## **Review of Mechanical Services Plant Proposals At Spectrum House**

**SPECTRUM HOUSE  
32-34 GORDON HOUSE ROAD  
LONDON  
NW51LP**

HM REFERENCE: **32124-RP-EB-001**

**Y Series VRF  
(130-150kW)**Heat Pump Outdoor Unit  
(Heating or Cooling)***Typical “VRF” System (Mitsubishi)***

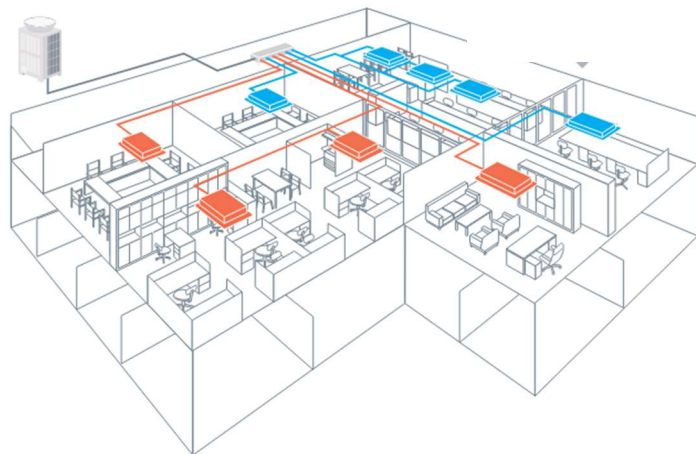
It is noted that this type of system has been investigated as overall it would require less external condenser units mounted on the roof. It is noted that this type of system has been deemed unsuitable to be used as:

- The weight of external VRF units are significantly heavier than split unit condensers and the existing lightweight roof structure would not be able to support them without significant structural intervention.
- VRF units are taller than split unit condensers which would require the plant screen to be higher than is currently proposed which would have a resulting visual impact.

Therefore, where new heat pumps are proposed to replace existing gas and electric heating they have been based on “split” type systems following the principle of the the existing heat pump systems in the building.
